## **Report of the Joint Review Panel**

### **Benga Mining Limited Grassy Mountain Coal Project**

**June 17, 2021**

Decision 2021 ABAER 010: Benga Mining Limited, Grassy Mountain Coal Project, Crowsnest Pass

Figure 5-2. Mine permit boundary. Source: CIAR 571, Appendix A, Figure 1, PDF p. 38.

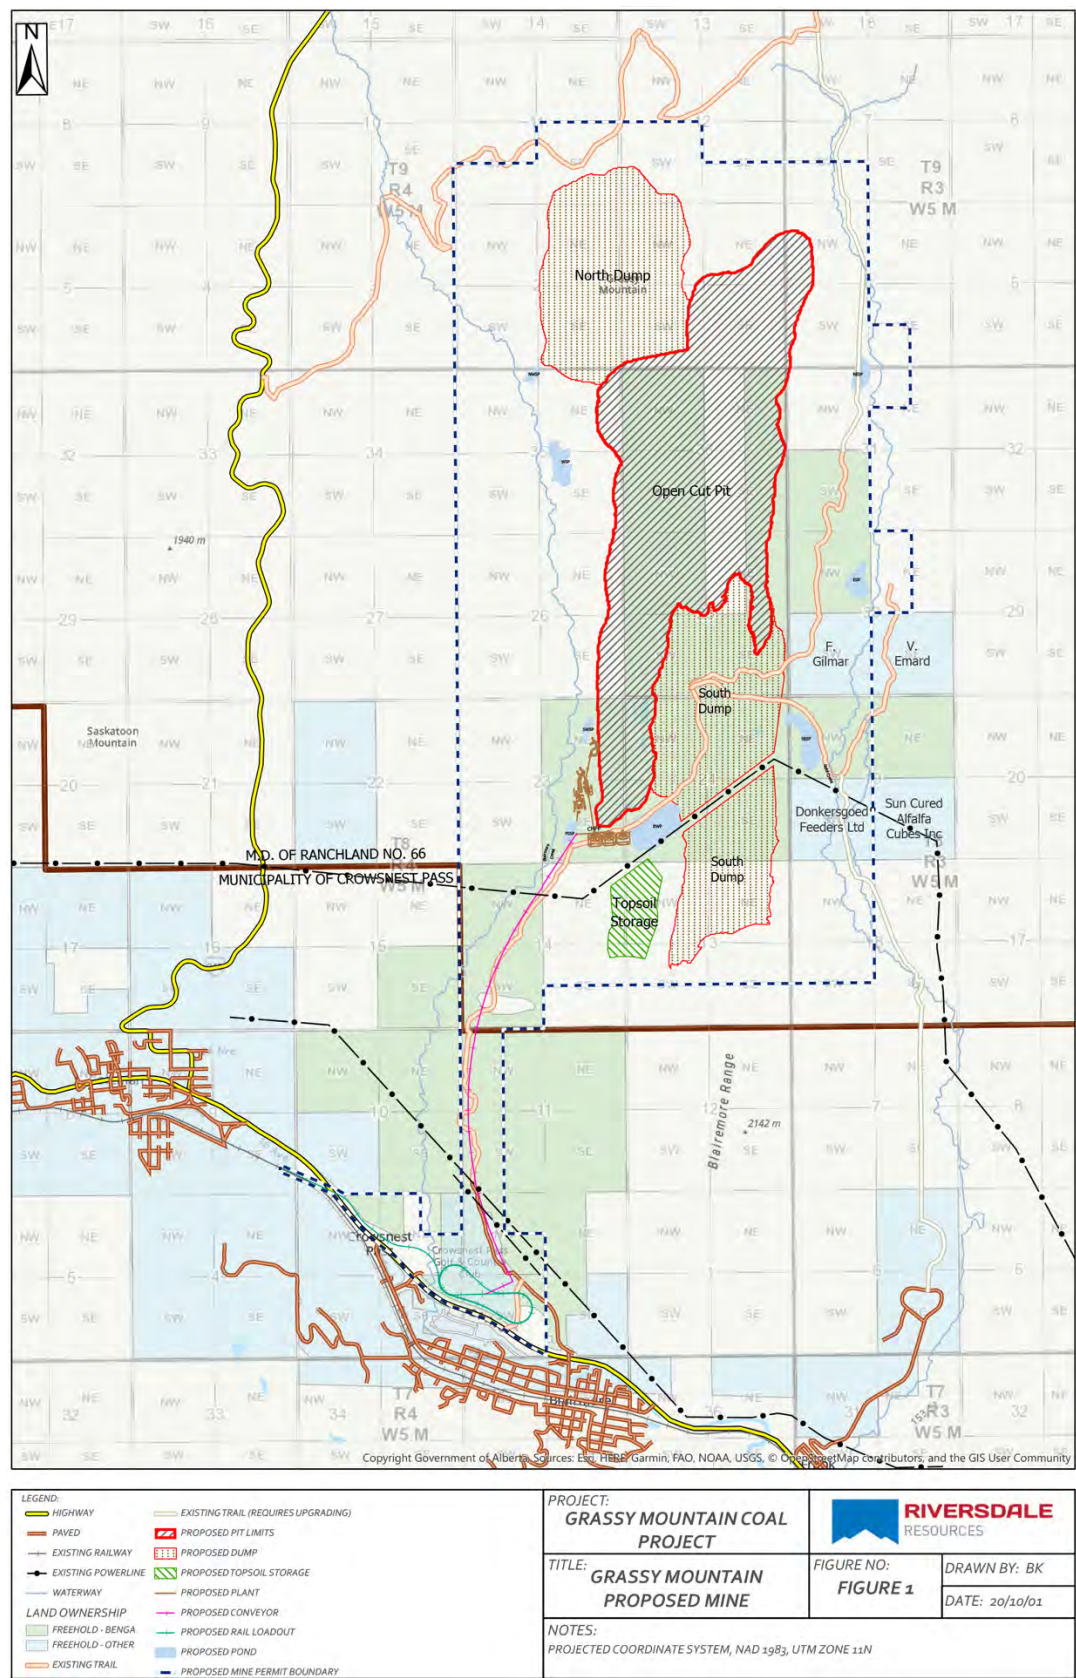
The applied-for mine permit boundary includes lands not controlled by Benga

[277] In response to questions at the hearing, Benga confirmed that the mine permit boundary it applied for includes private lands belonging to F. Gilmar and Donkersgoed Feeders Ltd. Benga also confirmed that the Gilmar and Donkersgoed lands are not essential to mining at Grassy Mountain and could be excluded from the permit area. In response to questions at the hearing, Benga also confirmed that it does not control and has not submitted applications under the *PLA* to make use of areas west of Blairmore Creek or east of Gold Creek as these areas are not required for mining.

**Figure 13-3. Selenium species remaining in effluent after application of an advanced oxidation process (AOP), in a presentation slide supplied by Teck Resources.** Source: CIAR 503, PDF p. 65.

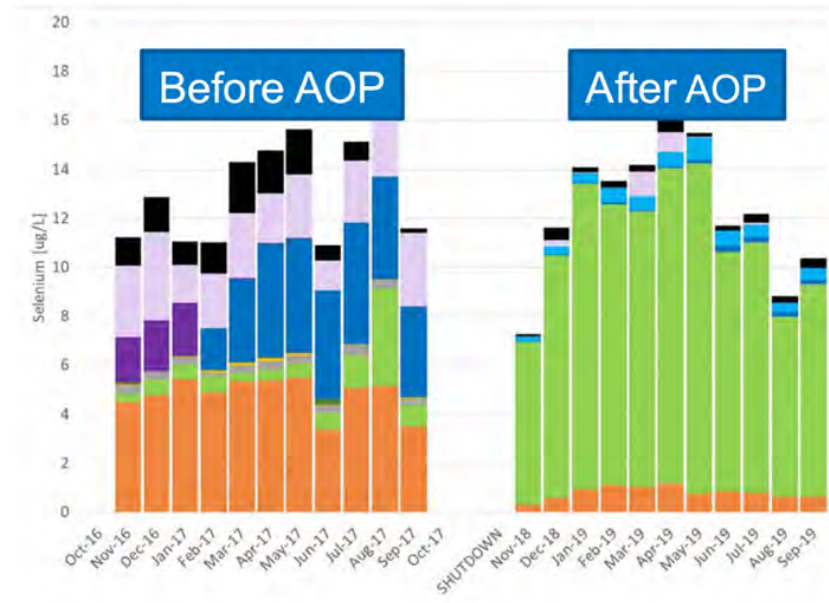
[961] Benga submitted a Teck presentation on its selenium treatment results shortly before the hearing, which included a figure apparently illustrating results for the advanced oxidation process at West Line Creek (Figure 13-3). The figure did not have a legend, and Benga provided no explanation of the results, but given that Benga suggested the advanced oxidation process successfully converts other forms of selenium into selenate, we can assume that the bars on the right represent an increase in selenate. If so, we

note that the figure appears to indicate that a mix of selenium species remained in the effluent, even after Teck applied the advanced oxidation process.

**Figure 15-1. Pre- and post-mining topography.** Source: CIAR 251, Package 2, Figure F.4.1-6, PDF p. 228.

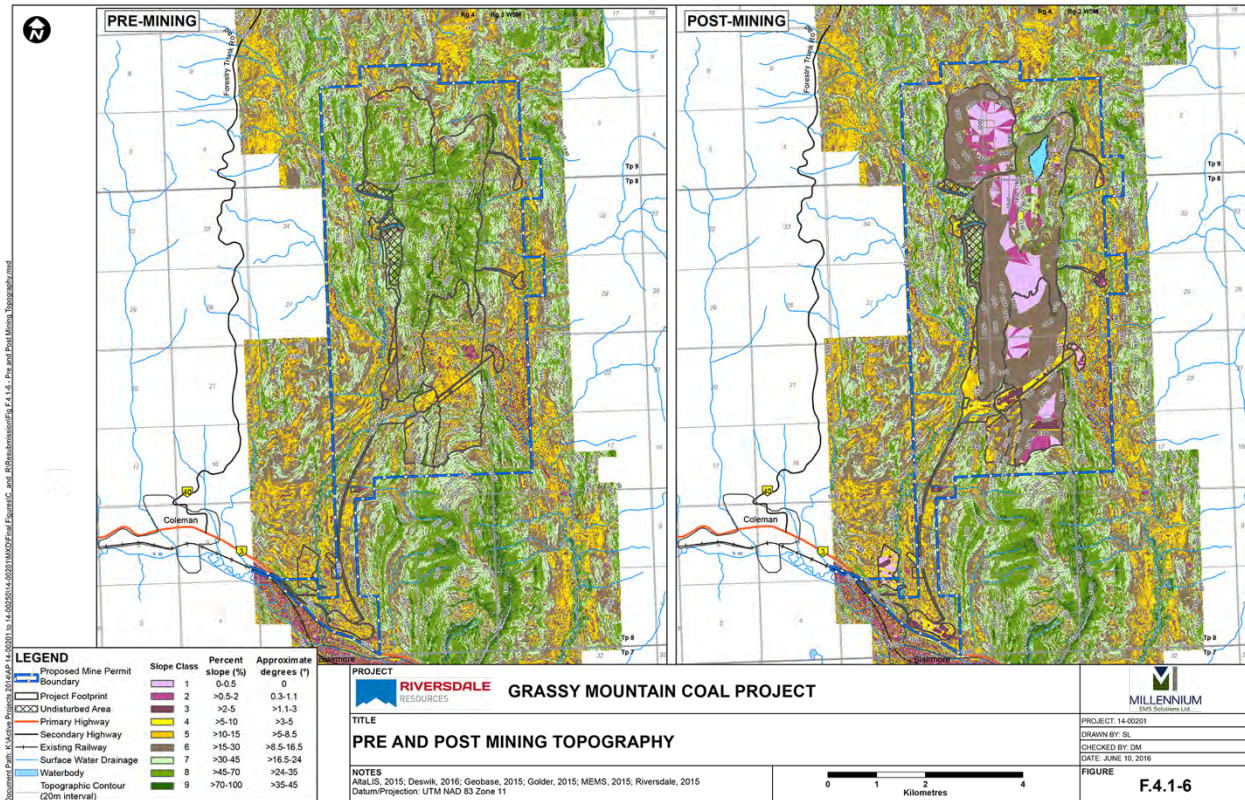
[1418] The Livingstone Landowners Group said that, while Benga promised aesthetics in the reclaimed landscape, it provided little supporting information. The group noted that most mines use visualization techniques to explain to staff, regulators, and local communities the vision for the mine's reclamation. These techniques show what the mine will look like from various points on the site and offsite before mining, during mining, after reclamation is complete, and in the long term. They noted that such information was not provided by Benga. The information in the EIA was limited to text, maps, and cross-sections.
